CITY OF SEASIDE
BOARD OF ARCHITECTURAL REVIEW

**CITY OF SEASIDE
STAFF REPORT**

SUBJECT: **Board of Architectural Review Application No. BAR-16-09.** Design review approval for the construction of a second story addition to an existing one-story single family residence located at 2090 Mariposa Street in the Single Family Residential (RS-8) Zoning District (APN 011-055-024). This project is Categorically Exempt Class 1, Section 15301.e.2.A, Existing Facilities, from the California Environmental Quality Act.

HUBBLE REMODEL

1
A4.0
SCALE: 1" = 1'-0"

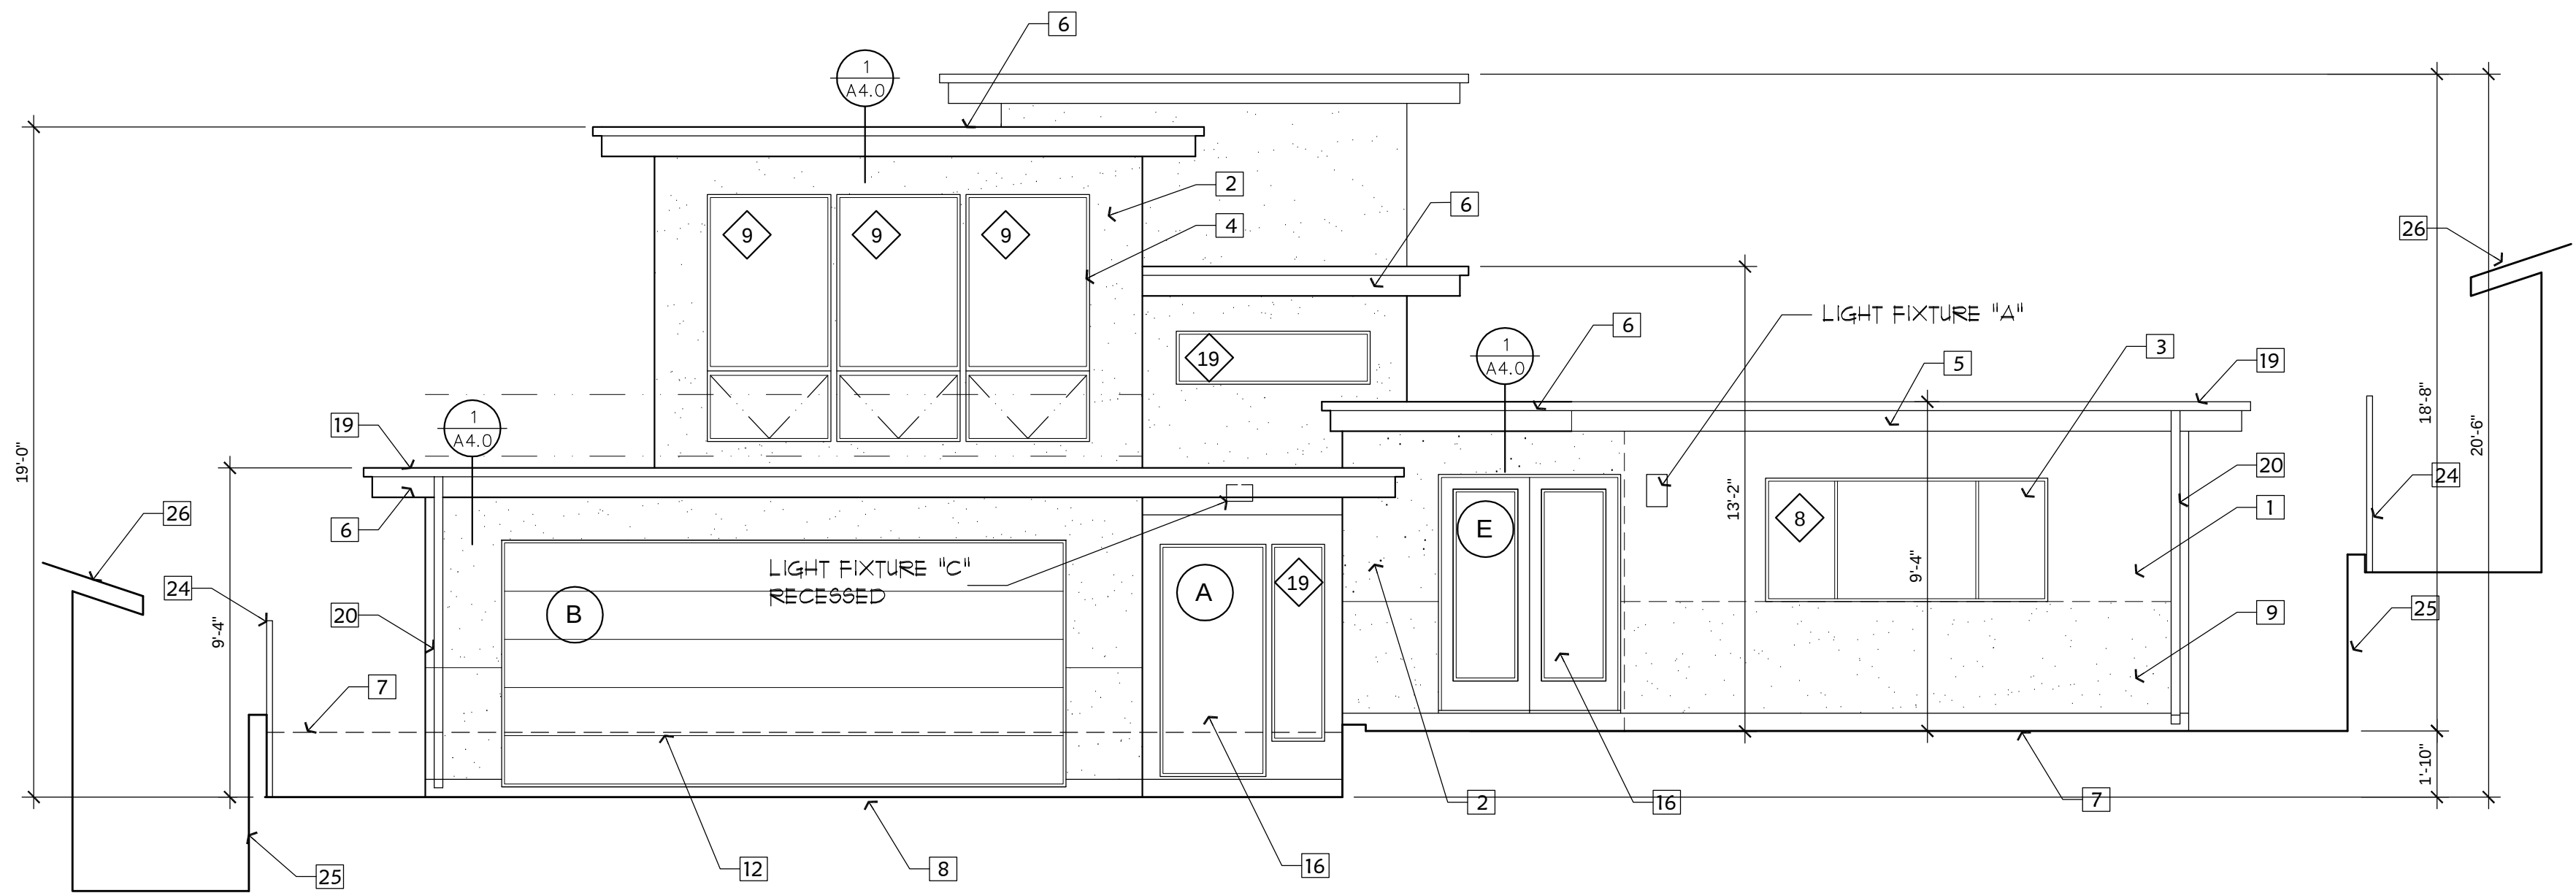
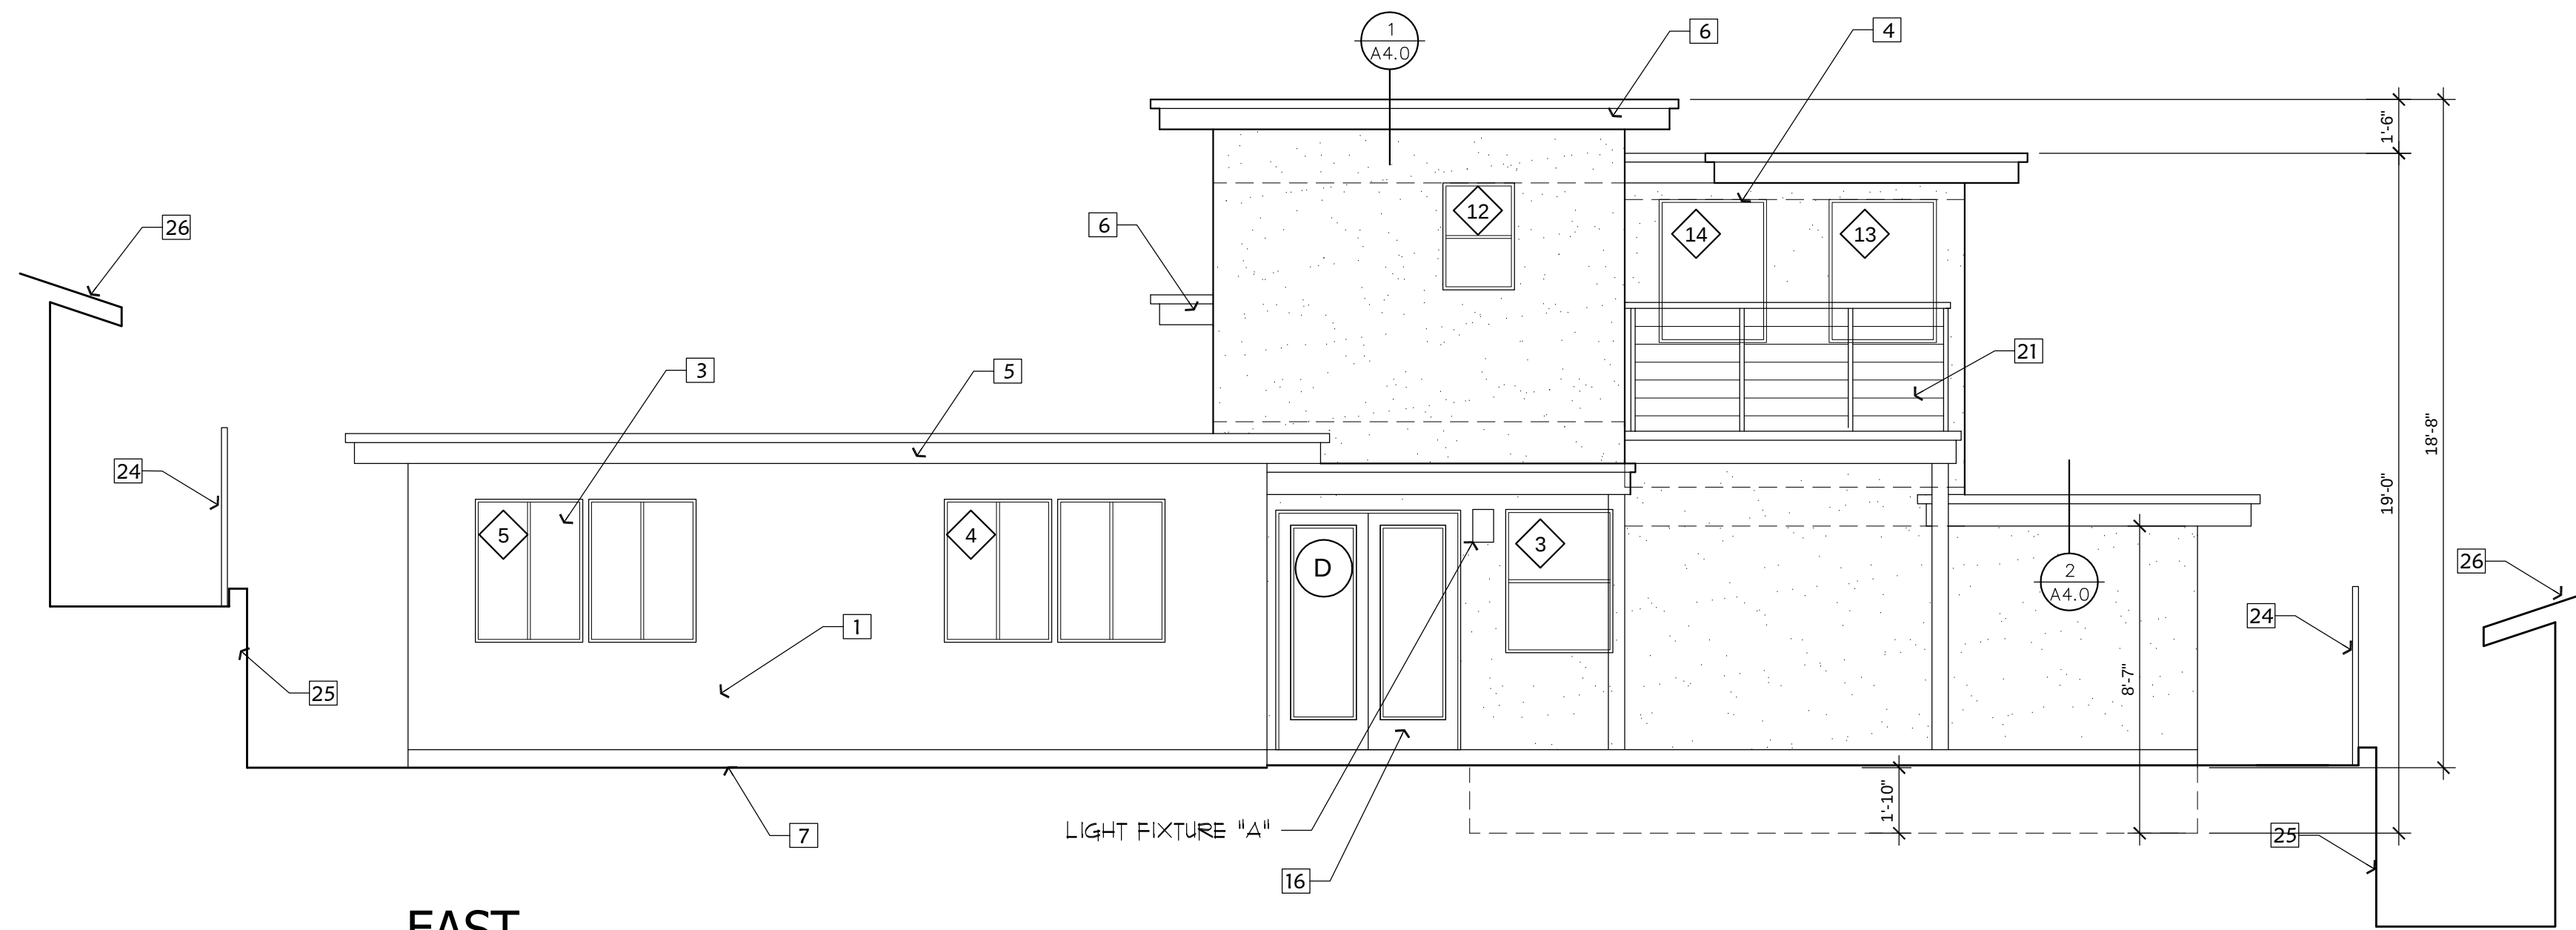
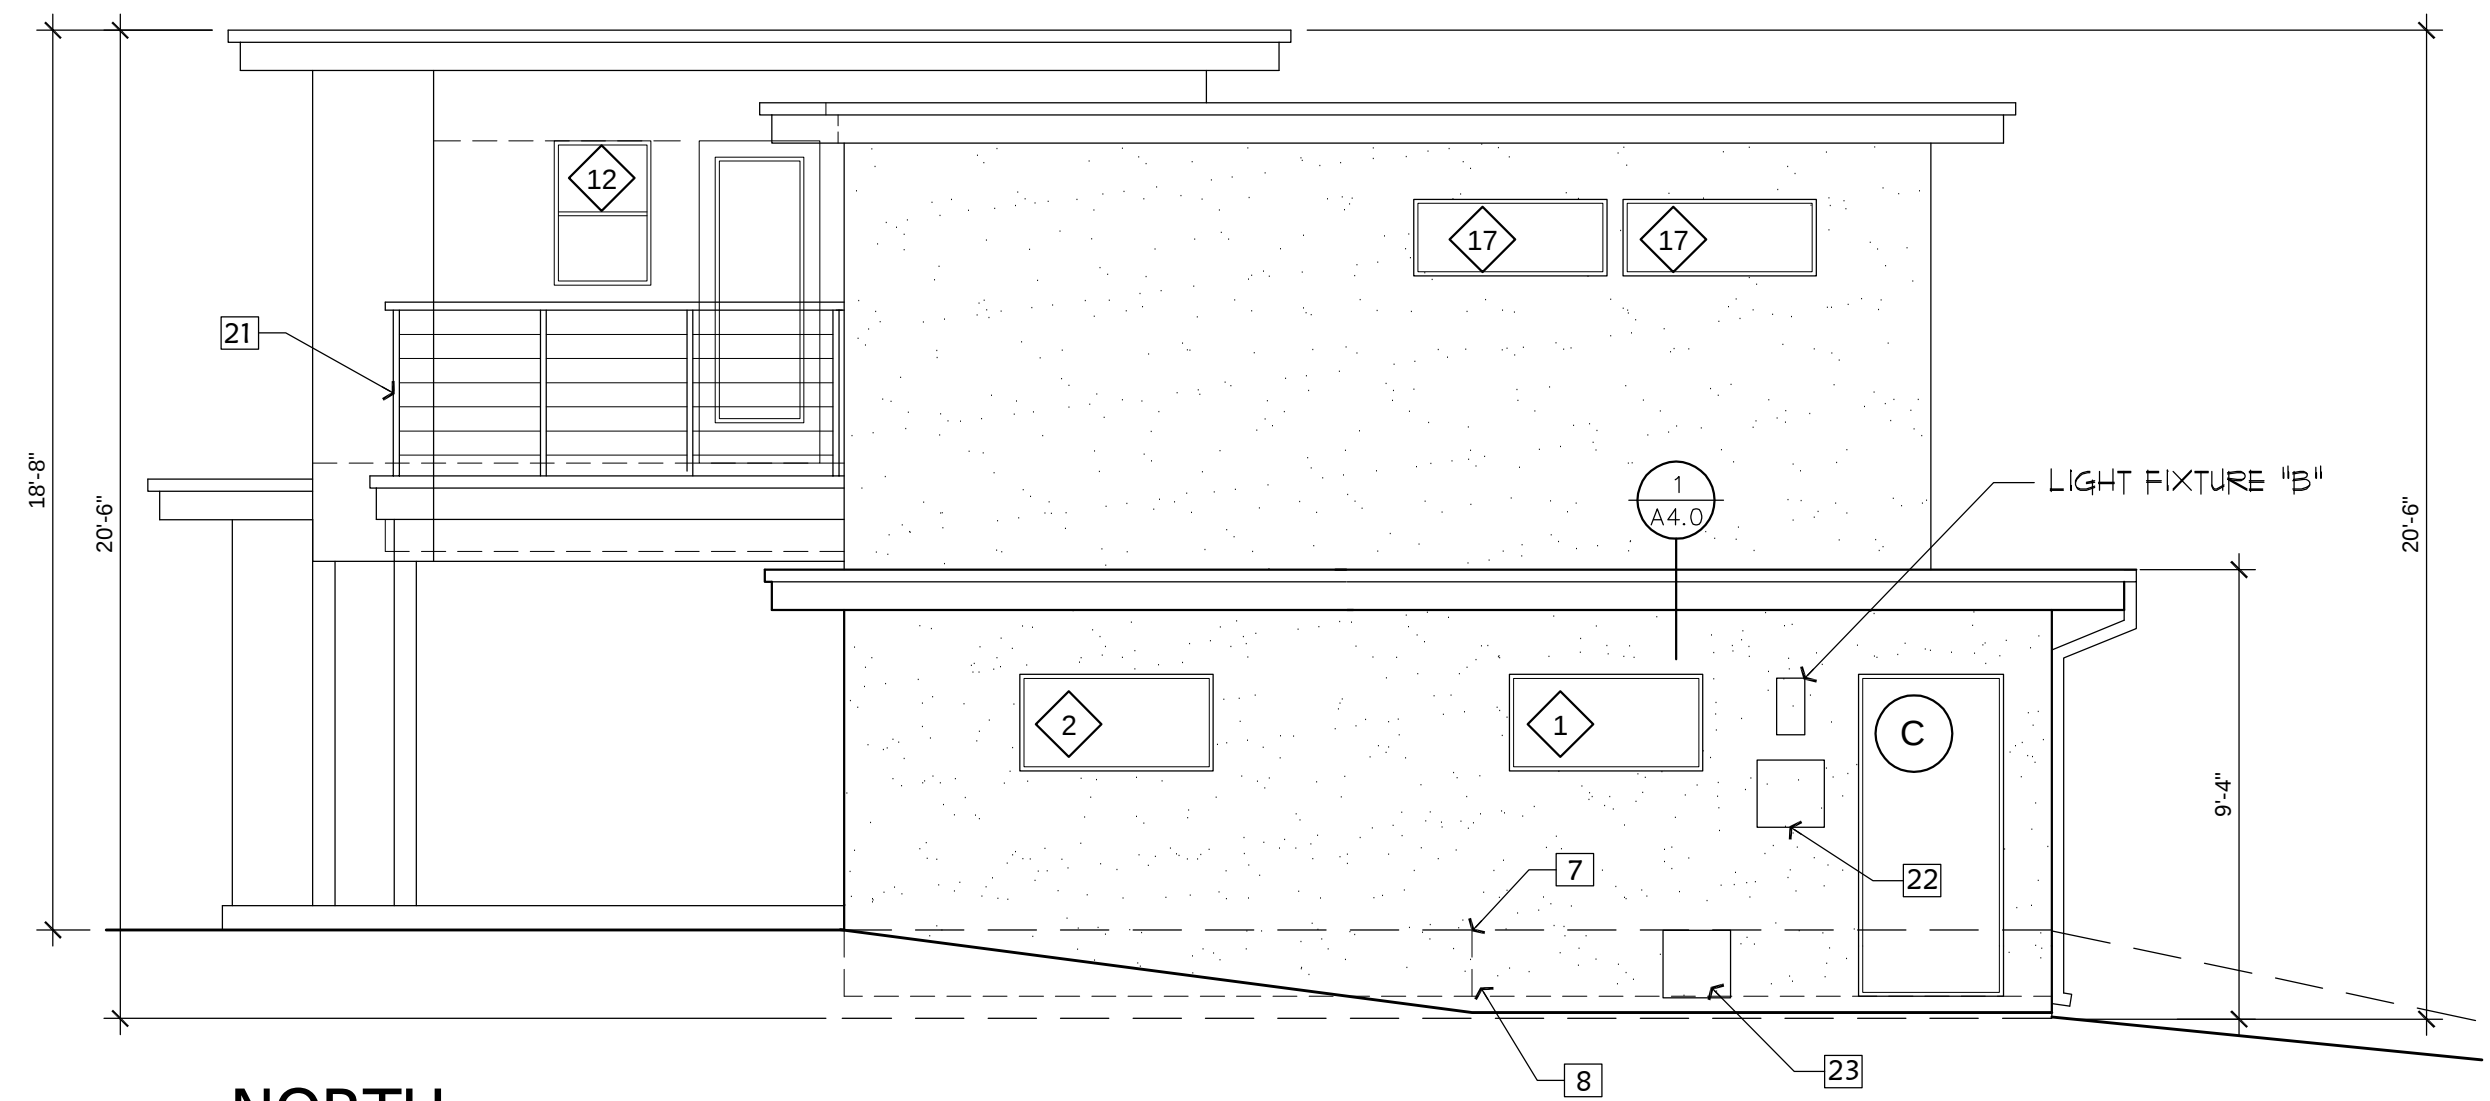
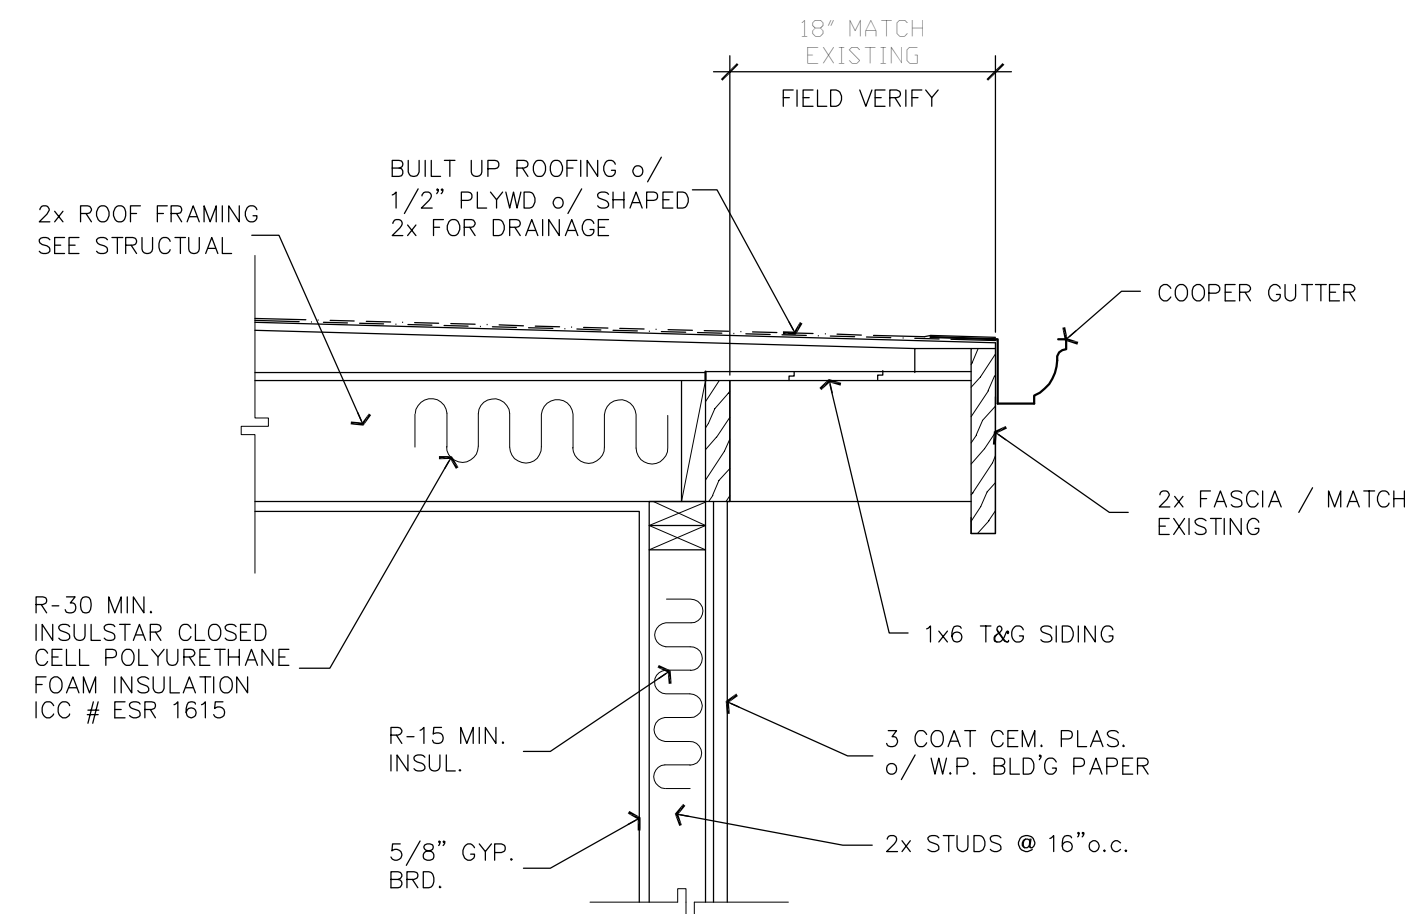
B. Consider modifying the north elevation of the second story to increase the side setback from the first floor below along the entire north side to create a setback transition between the one-story dwelling on the adjoining property to the north.

C. Porch and wainscot details.

B. The north elevation has been modified to increase the second story setback from five feet to eleven feet six inches thereby enhancing the transition between the one-story dwelling to the north.

C. The applicant has removed all existing and proposed exterior wood siding from the front elevation of the house. All exterior additions will be stucco to match the existing house. New wood doors, metal windows, and copper downspouts and gutters will remain per the original design.

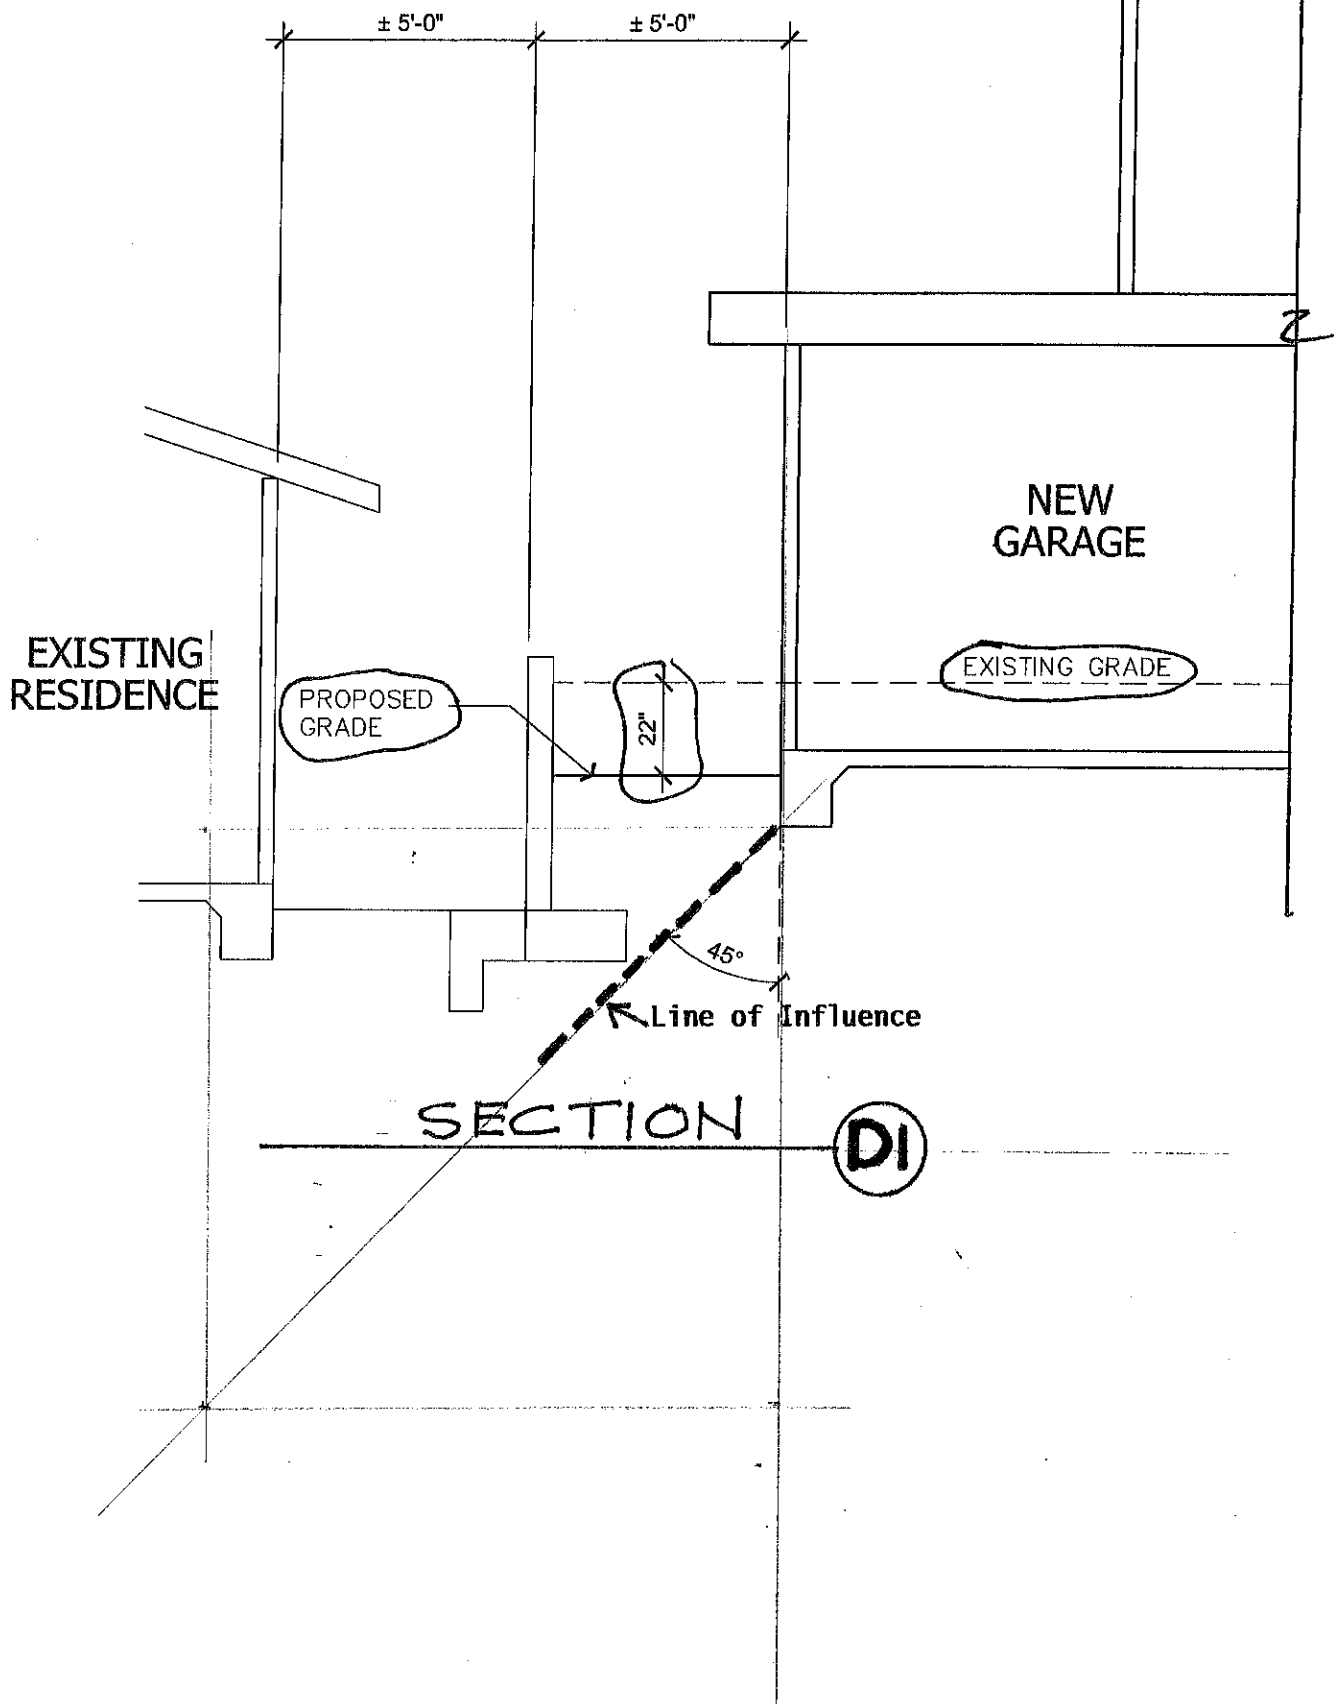
The major issue is the structural integrity of the existing property line retaining wall and to verify that the addition will not put a surcharge on the existing retaining wall.

Note that the addition lowers the existing grade by 22", thereby substantially reducing the lateral pressures on the retaining wall, see attached calculations, page 3.

The bottom of all new footings will be specified to be below the line of influence of the existing retaining wall footing, thereby not adding any lateral pressures on the wall due to the addition, see attached Section, page 2.

To summarize our findings, we can state that the addition reduces the lateral forces on the existing retaining wall and can be safely build.
